Iowa City Historic Preservation Commission

IOWA CITY HISTORIC PRESERVATION COMMISSION

Thursday, October 10, 2019

Staff Report

A2

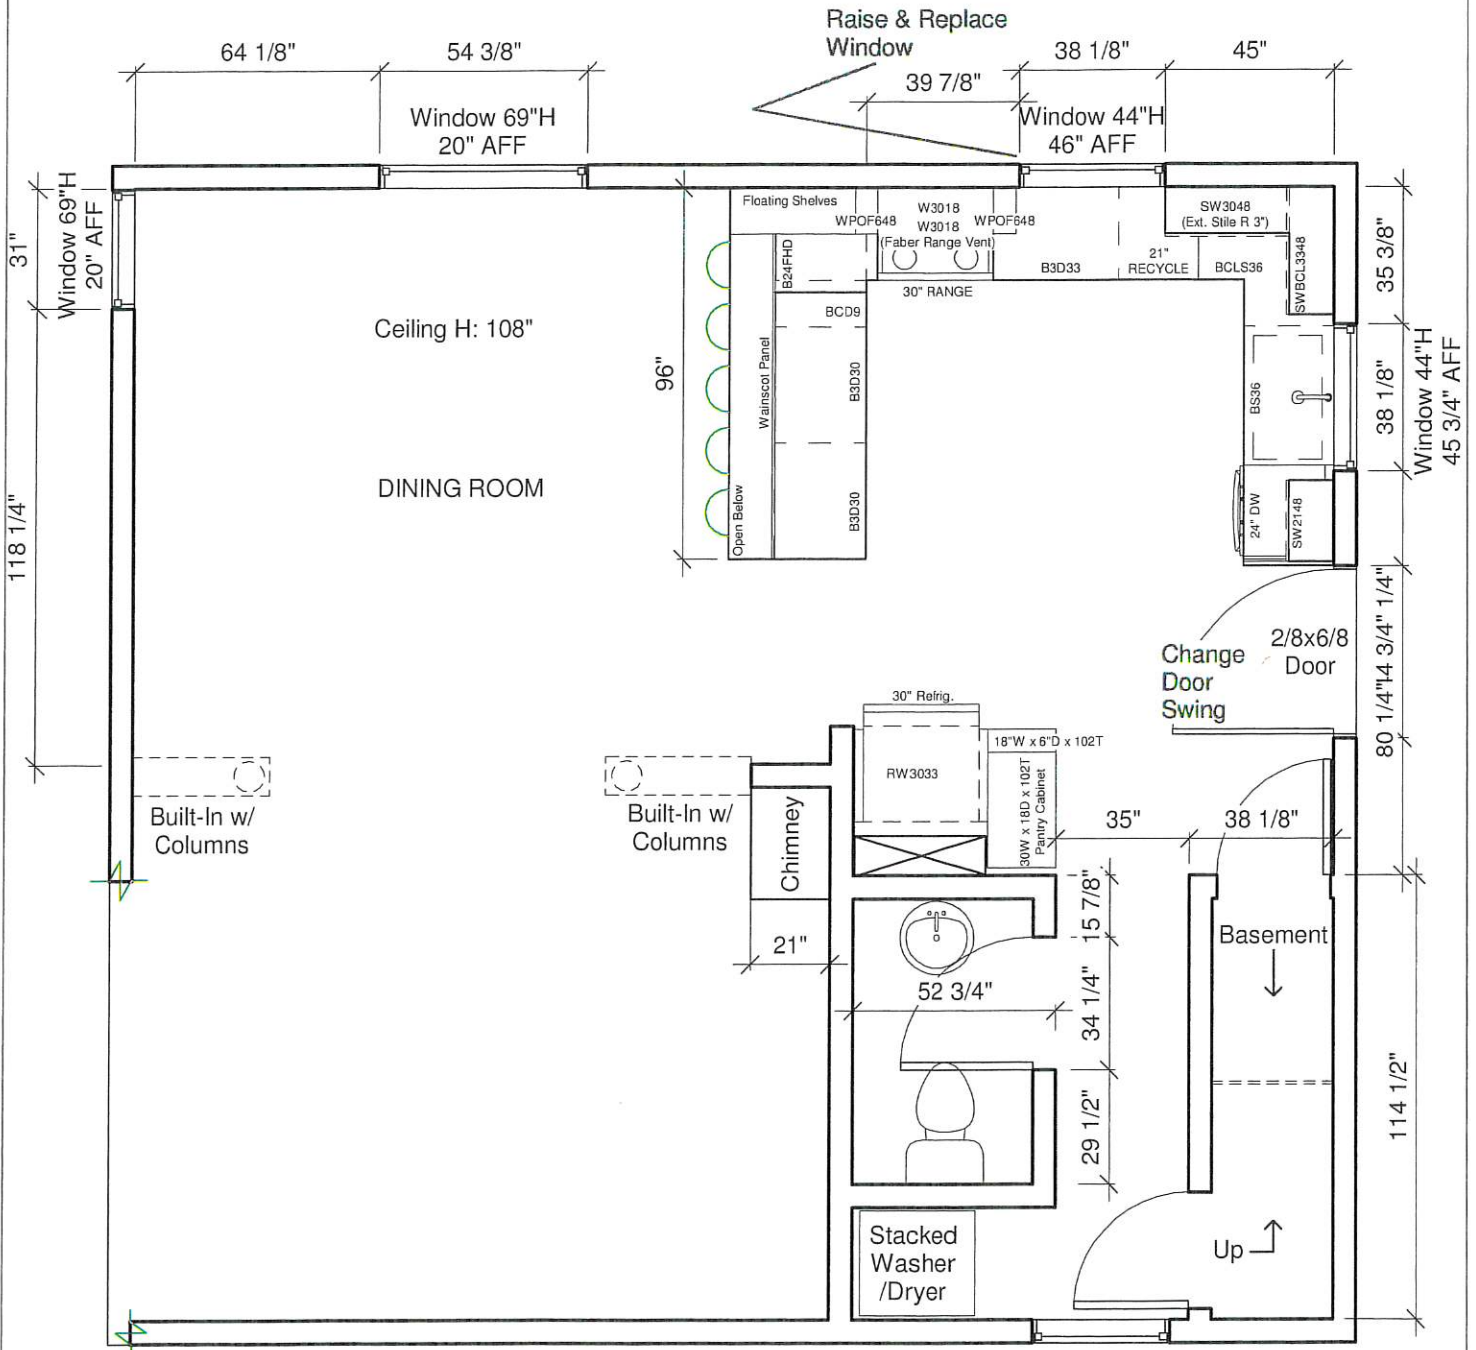
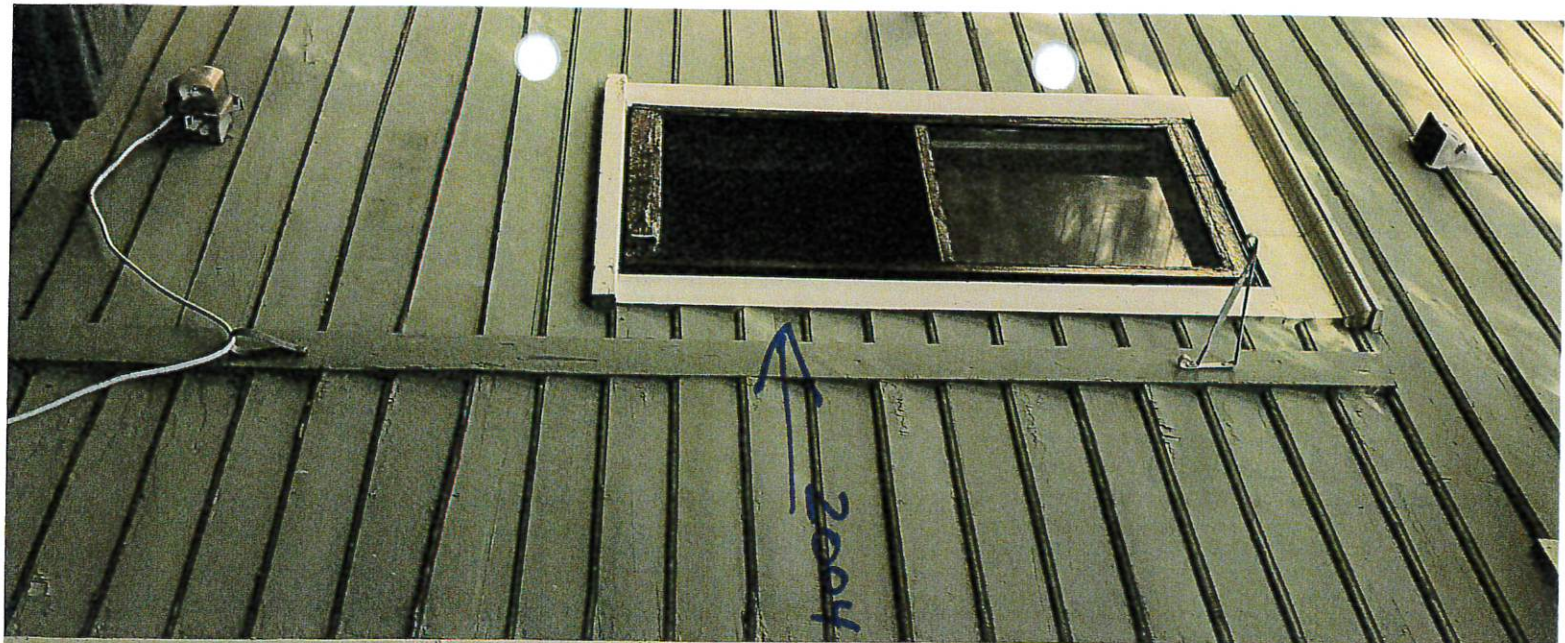
The applicant is proposing to alter the east-facing window at the rear of the first floor of the house by raising its sill to avoid a new kitchen counter. The new window will be a Windsor Pinnacle metal-clad double-hung window that will match the sill height of the window around the corner to the south which was approved in 2004.

In Section 4.13 Windows, the guidelines recommend that new windows should be metal-clad wood or wood and match the divided-lite condition of the existing historic windows as well as the size, profile, and trim. The sashes should be black. If a window is to be relocated or added, it should not detract from the overall fenestration pattern on the house. Small changes to window openings such as sill height, especially when located toward the rear of the house, have become changes that are regularly approved, gaining consensus as a change that allows for kitchen remodels to current standards and have little impact on the historic character of the home.

In Staff's opinion, this change, while on a street-facing side of the house, is toward the rear of the house and adjacent to a window that was also changed for this purpose in the past. The windows will match and the siding and trim will also match. Staff recommends approval of this application because it will facilitate a modern kitchen remodel and is a type of project that has gained Commission consensus over time.

Move to approve a Certificate of Appropriateness for the project at 1037 East Washington Street as presented in the application.

513 GRANT STREET

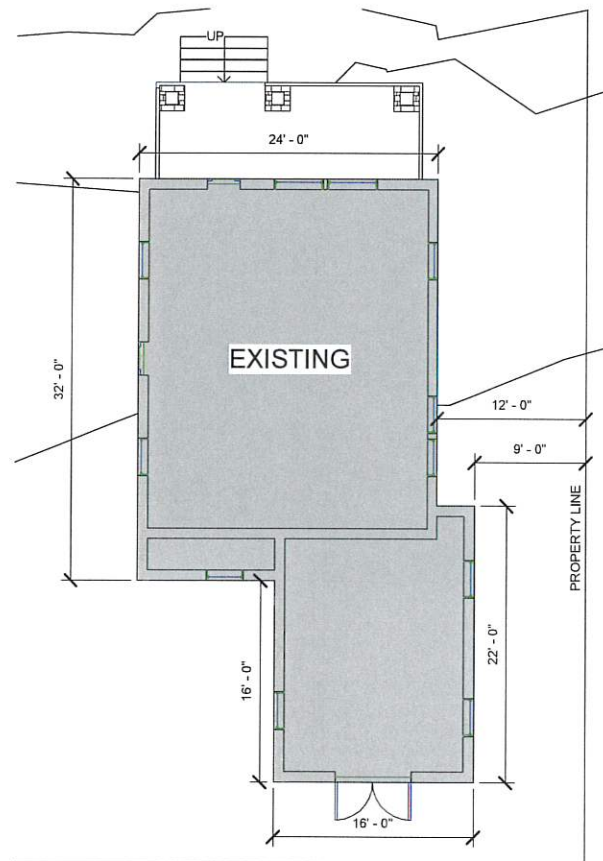
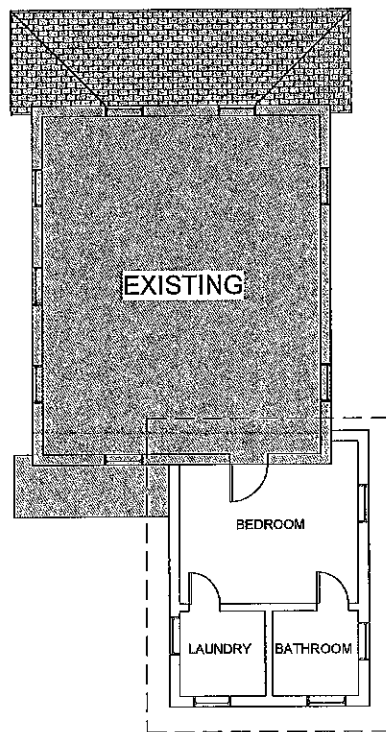
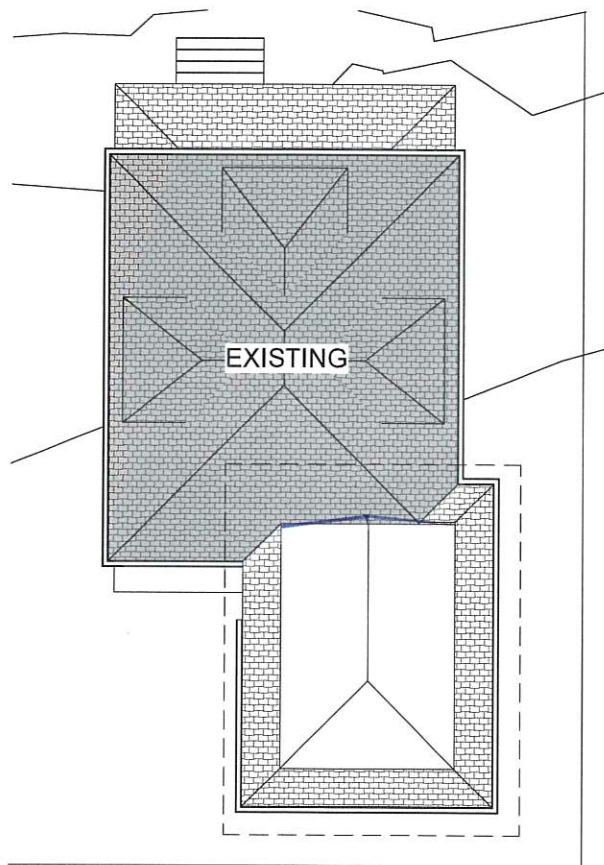
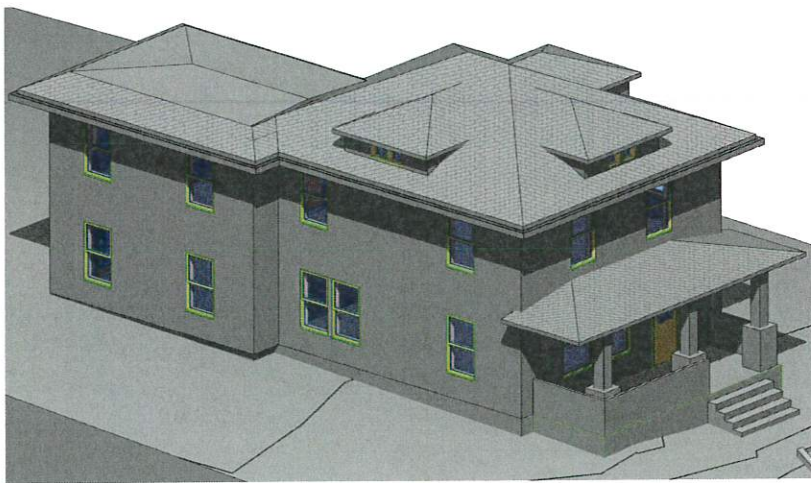
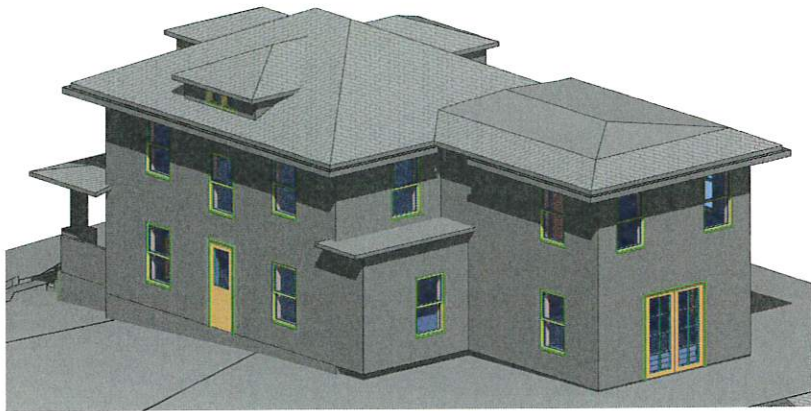
The applicant is proposing to build a second-floor addition over the existing first-floor addition while also modifying the existing addition so that it better fits with the historic architecture. For the existing addition, the siding will be removed and replaced with wood siding with a lap to match the historic house. The rear, or west, window will be replaced with a pair of French Doors to let in more light and provide exterior access. Only one section will be operable. On the south side, the pair of windows will be replaced with two individual windows spaced similar to the window patterning on the house. The window and door openings will have trim to match the historic portion of the house. The radon system will also be moved inside so that it projects through the roof, reducing its impact.

The new addition will continue the foot print of the existing addition up for a full second floor. The windows will generally match the window patterning on the house and relate to those in the addition as described above. The siding and trim will also match that on the house.

The design of the roof for the addition was not resolved at the time of the August 2019 Commission meeting. The Commission deferred further discussion of the project until the applicant could acquire additional drawings and work through the design of the roof. The existing first floor addition did not meet Historic Preservation guidelines that are intended to help minimize complications with the way additions tie into the historic house. Design of this roof was more complicated than an addition that meets the guidelines because of this past work. It had been determined that altering the 1973 addition to meet the guidelines was outside the scope of this project. Reducing the footprint of the second floor to meet the guidelines would create unnecessary structural issues. Two options that exist for most rear additions to a Foursquare, a flat-roofed

The newly design roof for the addition includes a roof edge or eave condition that matches that on the historic house. The slope, open soffit, and gutter will tie into the historic roof and continue around the perimeter of the new addition. Above the point where the new roof ties into the historic roof on the south side, the slope of the new roof changes to a very low slope hip roof. This change minimizes the impact and scale of the addition. It also simplifies the roof tie-in by reducing the distance in which the new roof would overlap the old. The low-slope portion of the roof will likely be covered in a membrane roofing while the matching eave condition will have shingles to match the main roof.

In Staff's opinion, the renovation of the existing first floor addition so that it reflects the historic character of the home will help reduce the impact of the addition. Moving the radon system inside will be a positive change. It could also be moved to the back of the addition and painted to match the wall to be considered appropriate. Replacing the windows on the addition to match the size, pattern, and type of the windows on the original house as well as changing the siding and trim to match are all appropriate changes for the existing addition. The reuse of the second floor window that will be removed for the addition is highly recommended. The proposed Windsor Pinnacle metal-clad windows are appropriate. Replacing the rear pair of windows with a pair of French Doors is an appropriate change to access the back yard and let in more light. Product information for these doors has not been submitted.

The current addition unfortunately is not set back from the side of the original house so that it meets the goals of the guidelines. By extending further south, the addition is seen from the street and creates a condition that makes it more difficult to tie in a roof on a 2nd floor addition. Staff worked with the applicant to determine whether or not it was appropriate to constraint the second floor to a smaller footprint than the first but it appeared to cause more problems, especially structurally, than it solved. Therefore, staff does find that the proposed footprint for the 2nd floor addition is appropriate. Similarly, because of the interior configuration of the addition, staff finds it appropriate to mimic the window patterning on the house instead of the sleeping porch model which would require more 2nd floor windows. Window product material has been recently submitted but not reviewed by staff. Staff finds this

Move to approve a Certificate of Appropriateness for the project at 513 Grant Street as presented in the application and staff report with the following conditions:

- Door product material is approved by staff
